CM30 University of Oxford

Engineering session

CM30 Engineering

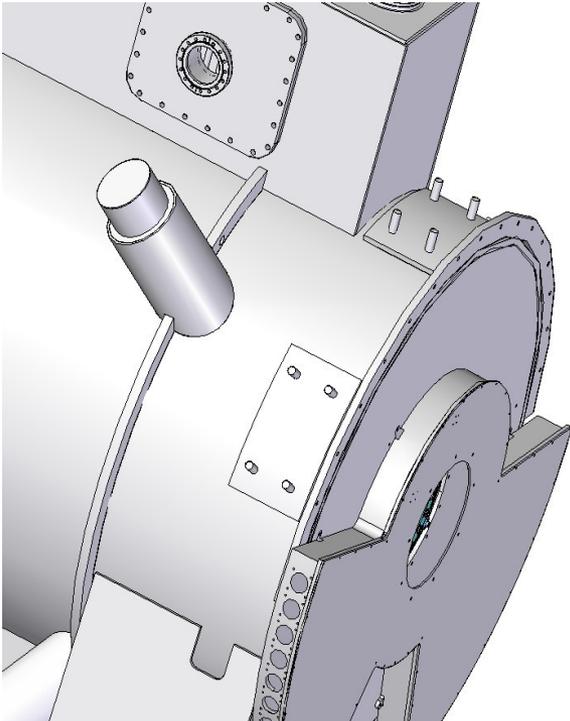
Can we work to specify the interface between the Spectrometer Solenoid and the Virostek plate support brackets? Currently welded pad with studs. RAL are going to produce a new design and drawings of the Virostek plate brackets, we need to make sure the RAL design interfaces with the Spectrometer Solenoid mounting pads.

Can we have pads welded to the Spectrometer that leave a flat surface to mount the brackets on?
Studs or blind tapped holes in the pads?

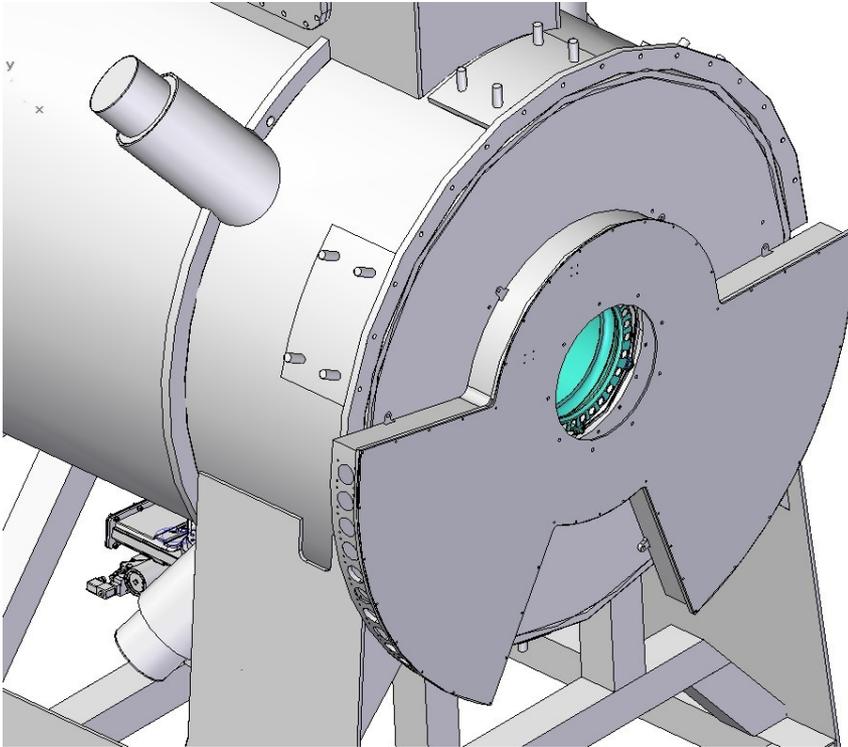
Do we understand all the patch panel interfaces for the spectrometer and tracker?
Do we have any drawings of the patch panel?
What is required for the patch panel seal?

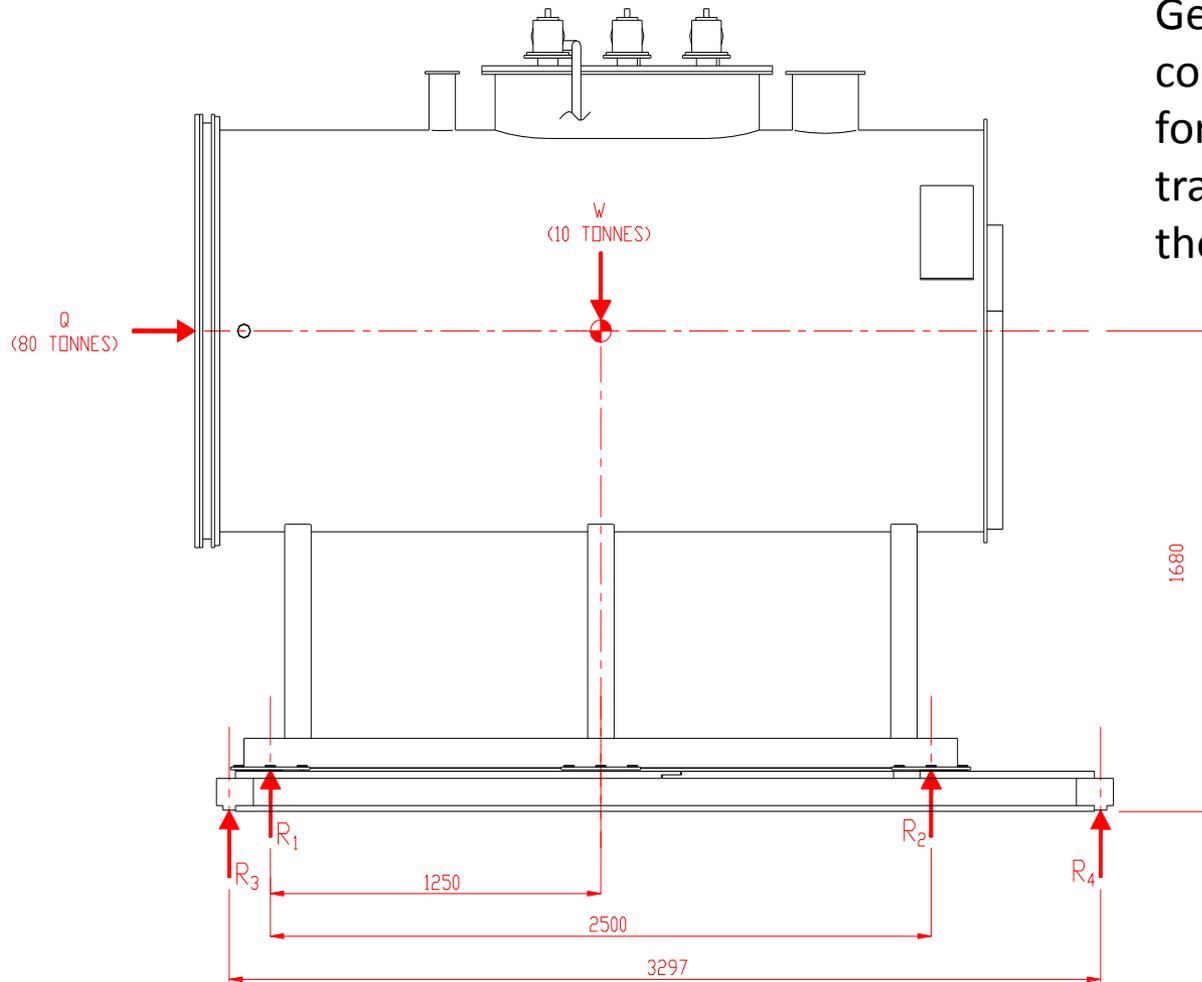
General discussion on the cooling channel magnet forces, how are the forces transmitted, are we all on the same page?

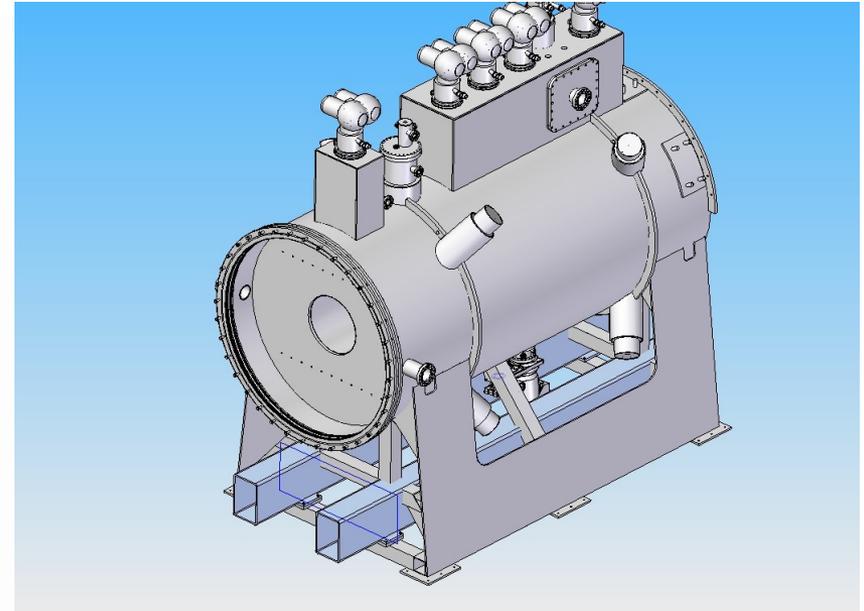
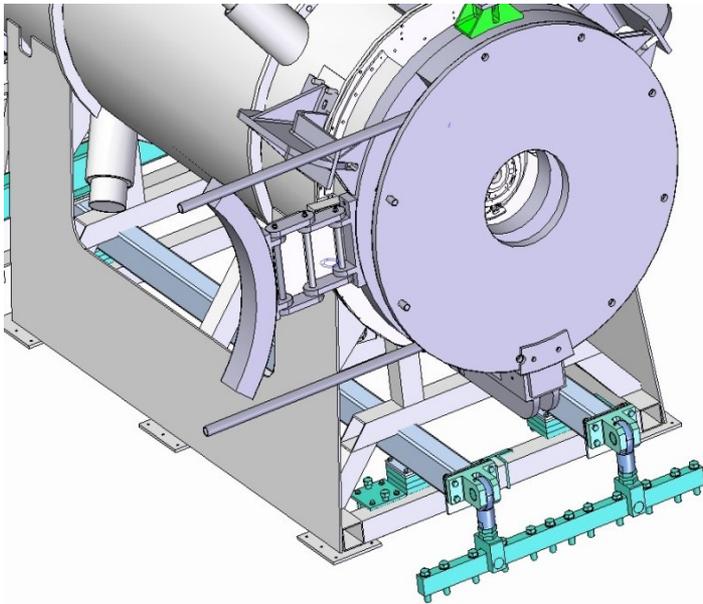
Currently there is a clash between the Spectrometer Solenoid support frame and the restraint beams.

Calculations show we need to increase the size of the restraint beam. Can we agree on the design for the Spectrometer base and restraint beam?

Are the forces we predict real? We are going to a lot of trouble to restrain the Spectrometer, is it really necessary?
